ITEM: 6.18	REPORT SUMMARY MINOR VARIANCE APPLICATION FILE NUMBER A193/24
------------	---

MINOR VARIANCE APPLICATION FILE NUMBER A193/24

CITY WARD #:	2
APPLICANT:	Giuseppe Nicola Cosentino and Rita Jinette Cosentino
AGENT:	Giuseppe Cosentino
PROPERTY:	55 Cromdale Ridge, Woodbridge
ZONING DESIGNATION:	See Below
VAUGHAN OFFICIAL PLAN (2010) DESIGNATION:	Vaughan Official Plan 2010 ('VOP 2010'): "Low-Rise Residential"
RELATED DEVELOPMENT APPLICATIONS:	N/A
PURPOSE OF APPLICATION:	Relief from zoning by-law is being requested to permit the construction of a pergola and cabana in the rear yard.

1 SITE PLAN & STATISTICS - COA
C-5 1:300

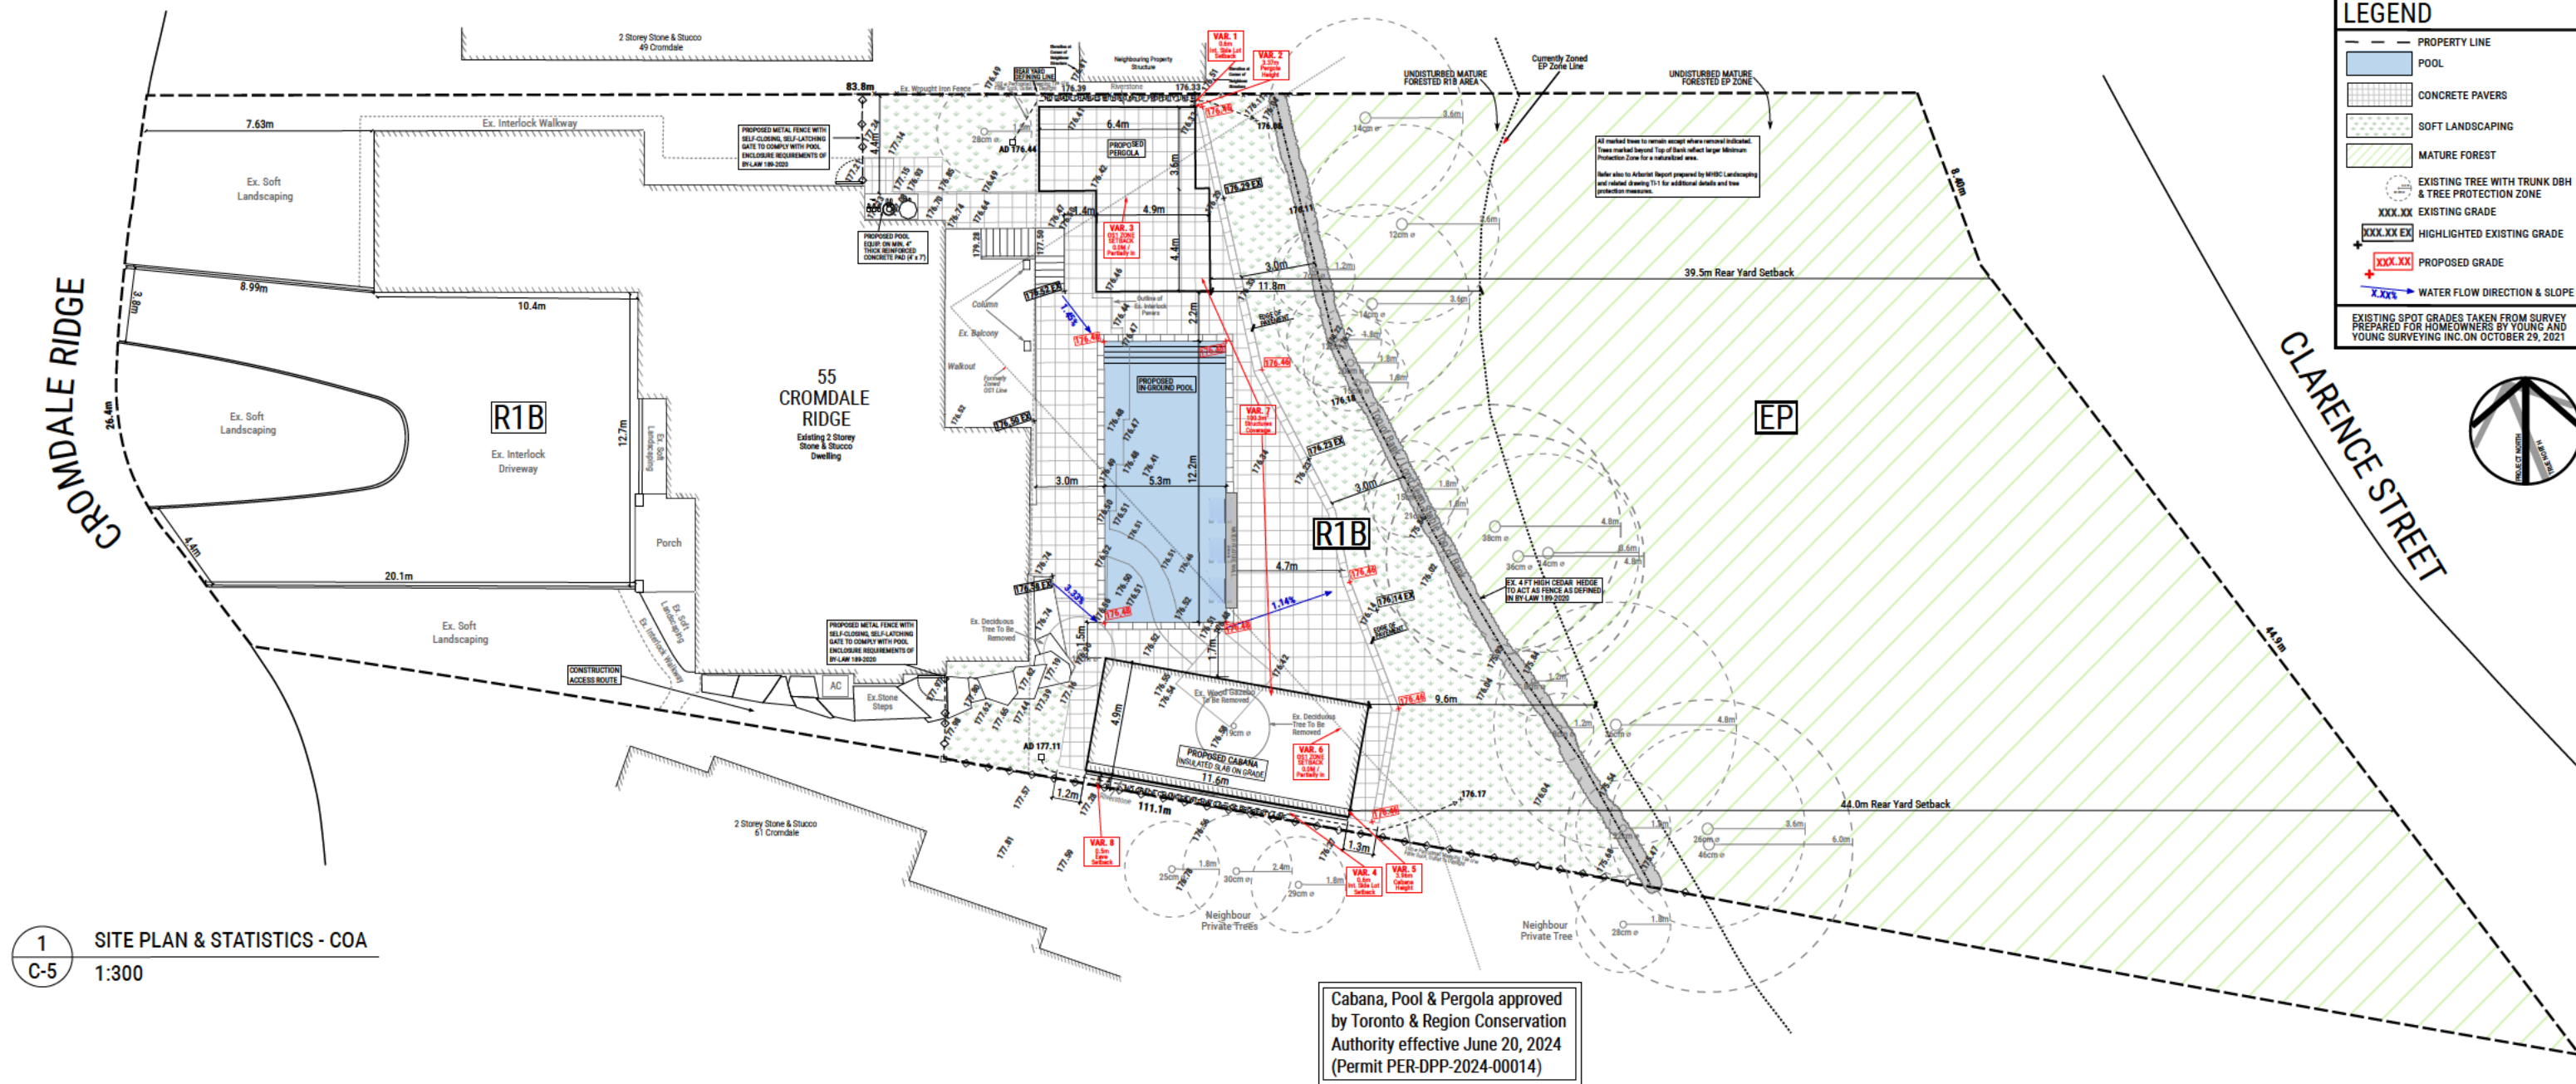
The Development and Parks Planning Department has no objections to Variances 1 and 2 to permit a reduced side yard setback and an increased height for the pergola. The proposed pergola is unenclosed and has minimum massing impact on the neighbouring property. The 0.6 m setback to the northern interior lot line is sufficient for access and maintenance.

The Development and Parks Planning Department has no objections to Variances 4, 5, and 8 to permit a reduced side yard setback, an increased height, and an increased eaves

The Development and Parks Planning Department has no objections to Variance 7 to increase the maximum permitted lot coverage of accessory buildings on the lot from 67 m² to 101.4 m². The rear yard is sizeable to accommodate the proposed structures, and the remaining area in the rear yard is sufficient to provide for a variety of landscaping and stormwater drainage functions.

The Development and Parks Planning Department has no objections to Variances 3 and 6 to permit the proposed cabana and pergola to be located within the Open Space 1 ("OS1") zone as shown on Schedule E-611 of site-specific exception 14.326. The intent of the OS1 zone boundary is to delineate the long-term stable top-of-bank line based on a topographic survey conducted in 1986. The site-specific exception requires a 10 m setback inland, which is based on TRCA standards from 1986. The current top-of-bank line was determined through a 2021 staking exercise and is located drawn further east of the top-of-bank line specified in 1986. TRCA staff have reviewed the Slope Stability Assessment completed in 2023 by EXP Services Inc. and are satisfied with the proposed locations of the structures. As such, the proposed setback reductions to the OS1 zone within the property maintain the intent of the site-specific provision.

Accordingly, the Development and Parks Planning Department supports the requested variances and is of the opinion that the proposal is minor in nature, maintains the general intent and purpose of the Official Plan and Zoning By-law, and is desirable for the appropriate development of the land.

The Development and Parks Planning Department recommends approval of the application.
